# TECHNICAL INFORMATION

63132

**Subject** ▶ Change of Ball Bearing

**For Models** ▶ 5017RKB

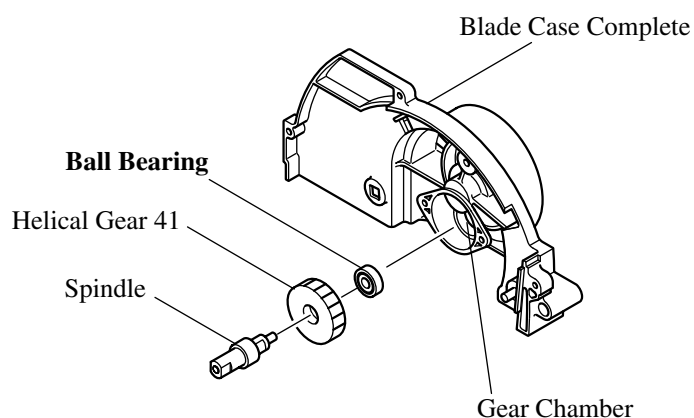
**Description** ▶ For quick repairing, the Ball Bearing in the gear chamber of Blade Case Complete has been changed from 608DDW (double sealed type) to 608 (seal-less type).  
(It is difficult to put a double sealed ball bearing in the gear chamber when there is much grease inside the gear chamber.)

|                             | ▶ <b>Current</b>                     | ▶ <b>New</b>                     |
|-----------------------------|--------------------------------------|----------------------------------|
| Cat. No.<br>of Ball Bearing | 608DDW<br>(With seals on both sides) | 608<br>(No seals on either side) |
| Part No.                    | 210005-4                             | 211034-0                         |

| Item No. | Current part                    |  | Q'ty | I/C | New part                     |  | Q'ty | Note |
|----------|---------------------------------|--|------|-----|------------------------------|--|------|------|
| 015      | Ball Bearing 608DDW<br>210005-4 |  | 1    | Yes | Ball Bearing 608<br>211034-0 |  | 1    |      |

From Serial No. 1341G (Apr., 2001)
